**HISTORIC LANDMARK COMMISSION
STAFF REPORT**

**Williams Residence
New Construction
PLNHLC2009-01421
February 3, 2010**

The applicant, Jake Williams, requests approval to construct a single-family dwelling with a detached garage at approximately 669 N. Wall Street. As part of the application, the applicant requests the Historic Landmark Commission modify the maximum height limit of 14 feet (14') for a pitched roof accessory structure to allow the garage to be approximately eighteen feet (18') from existing grade at its highest point and to be able to construct eaves on the structure.

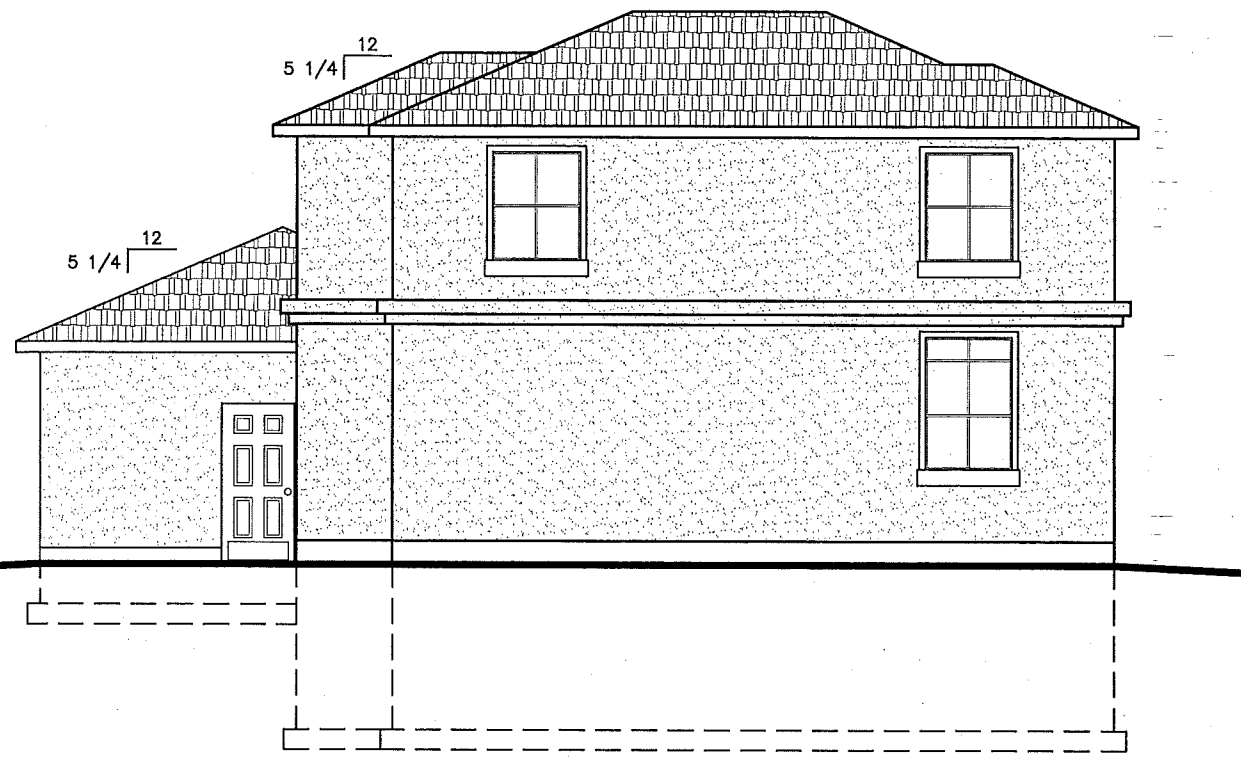
The 10x10 foot clear sight zone is fine as shown. See PDF redline drawing.
A public way permit will be required for the new drive approach type APWA 225.
